**Re: Former Chevron Service Station #9-7127
Interstate 580 and Grantline Road
near Tracy, California**

Re: Risk-Based Corrective Action - Tier 2
Former Chevron Service Station 9-7127
Grant Line Road at Interstate 580
Tracy, California

*Preliminary
Risk Assessment*

Table 1
RBCA Default/Site-Specific Data

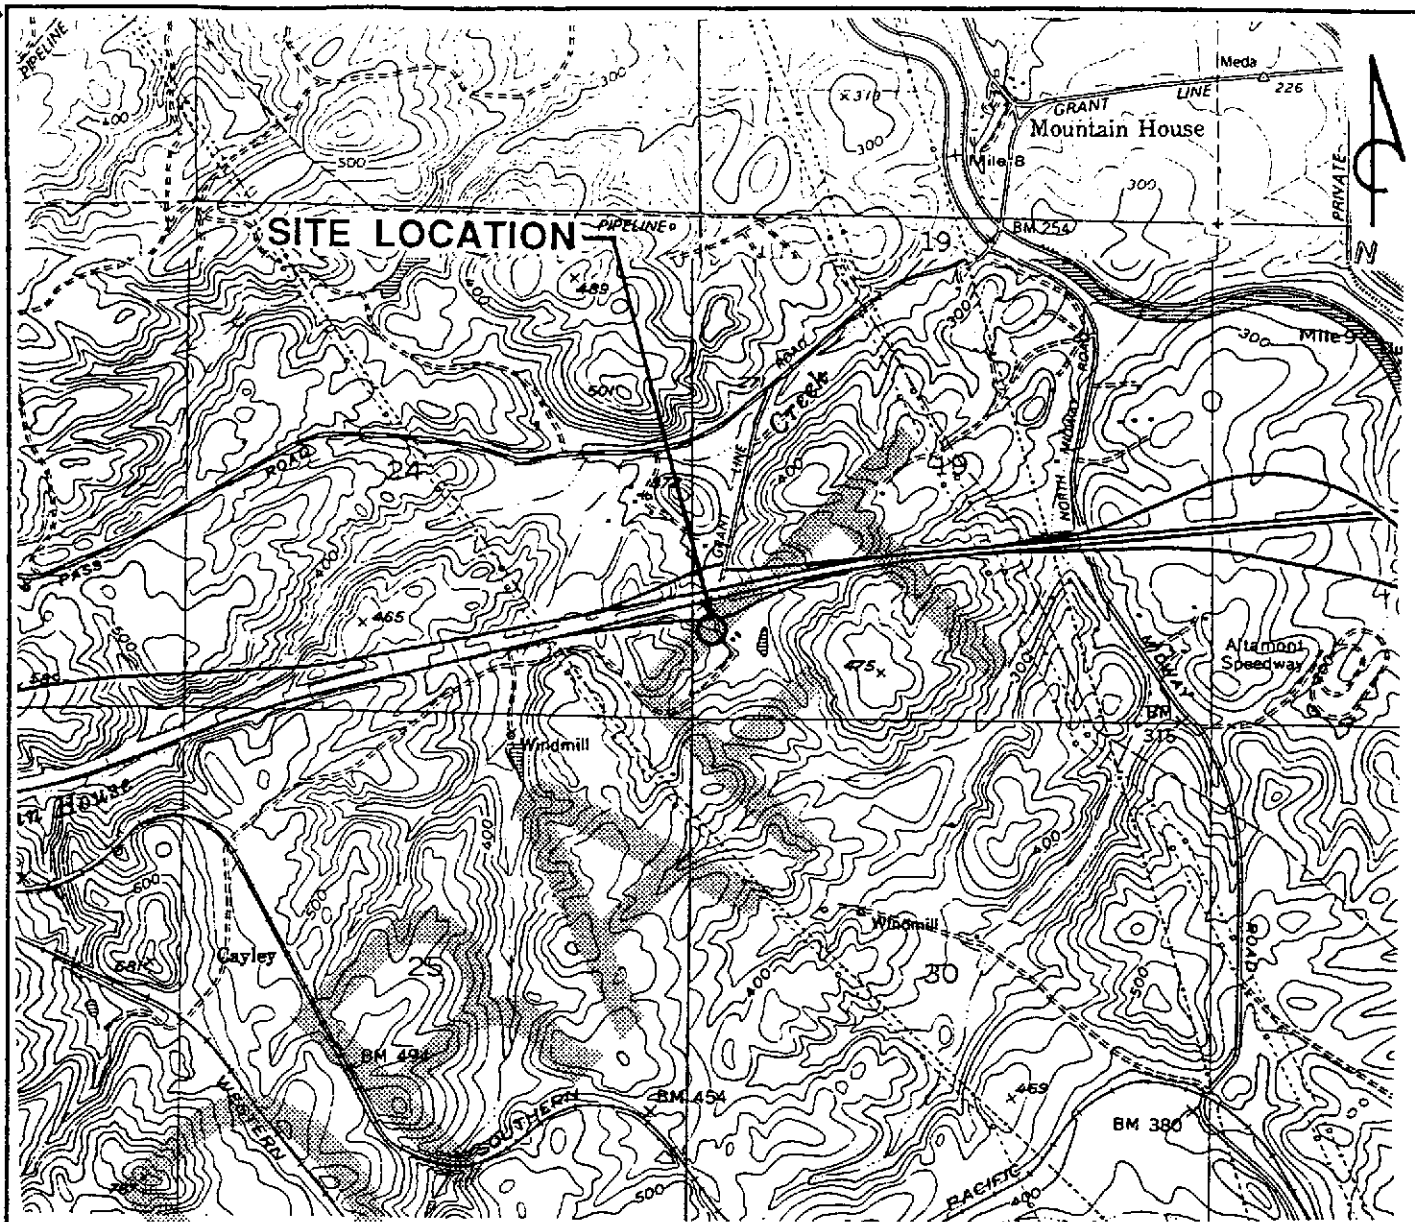
→ GW more like 29' if fill material is included - 13' is only for mws 5, 6, which is probably in wet embankment.

how were these determined

?

Building Factor
Crack Factor ?
